INTERSECTION SUGGESTIONS FOR RT TURN PAVEMENT INSUFFICIENCY

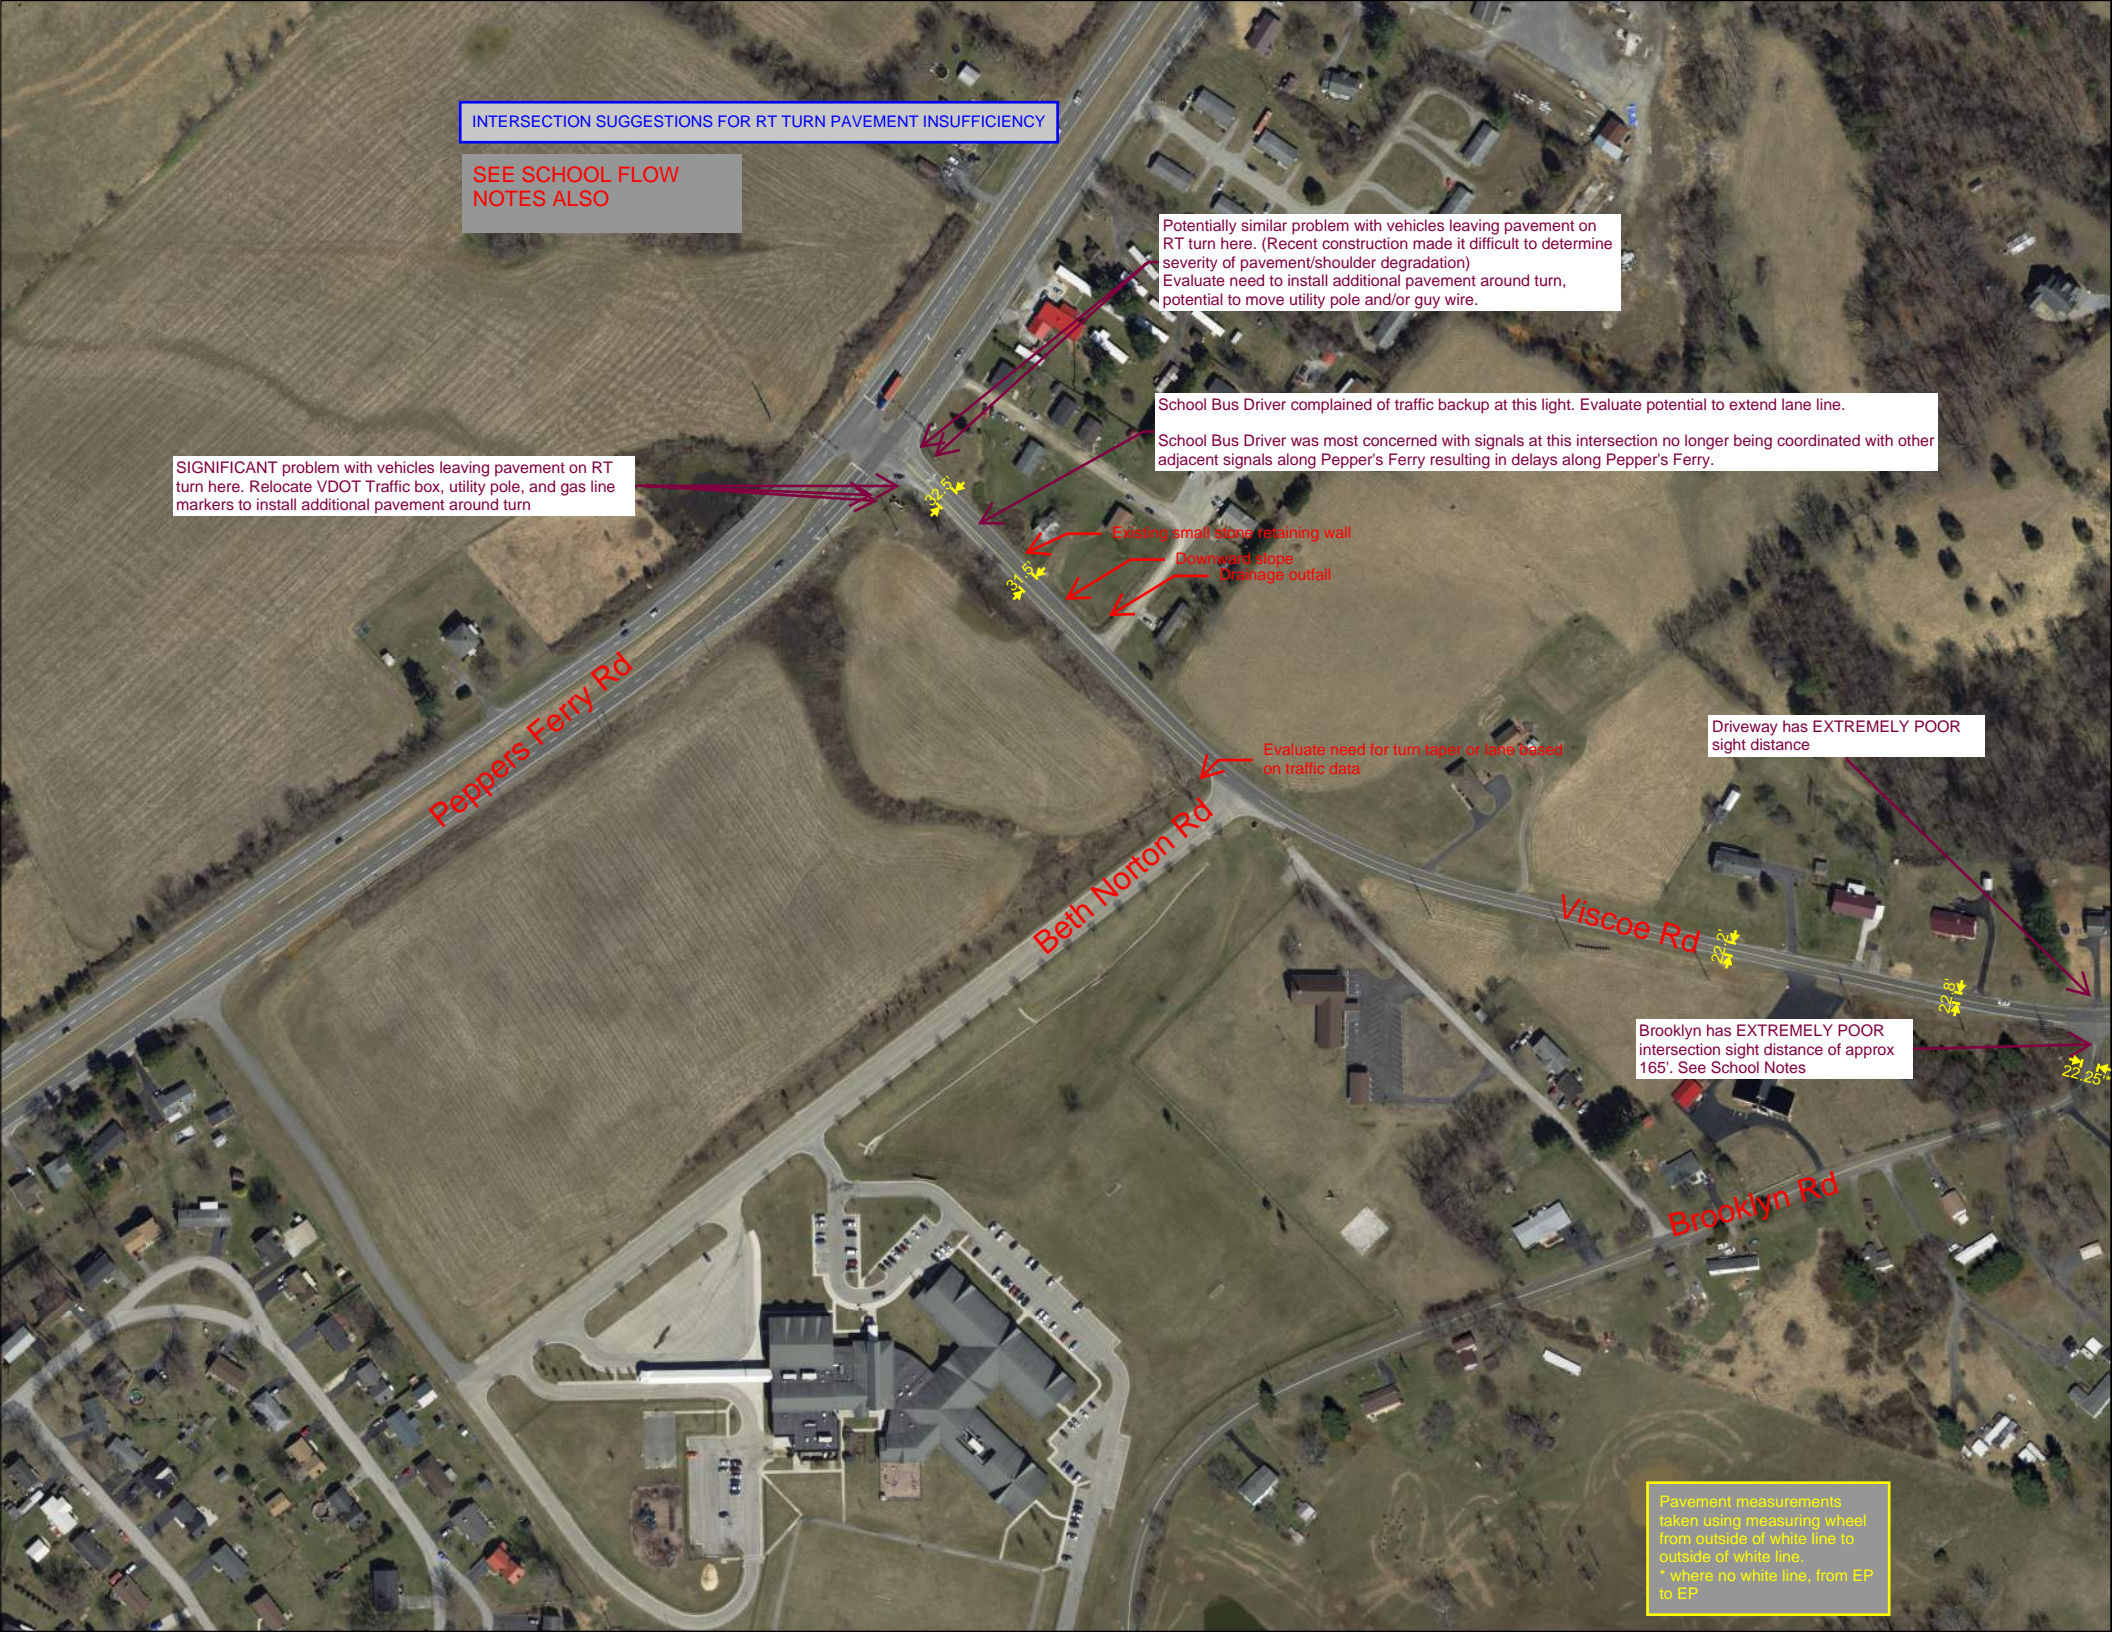
Potentially similar problem with vehicles leaving pavement on RT turn here. (Recent construction made it difficult to determine severity of pavement/shoulder degradation) Evaluate need to install additional pavement around turn, potential to move utility pole and/or guy wire.

School Bus Driver complained of traffic backup at this light. Evaluate potential to extend lane line.

School Bus Driver was most concerned with signals at this intersection no longer being coordinated with other adjacent signals along Pepper's Ferry resulting in delays along Pepper's Ferry.

SIGNIFICANT problem with vehicles leaving pavement on RT turn here. Relocate VDOT Traffic box, utility pole, and gas line markers to install additional pavement around turn
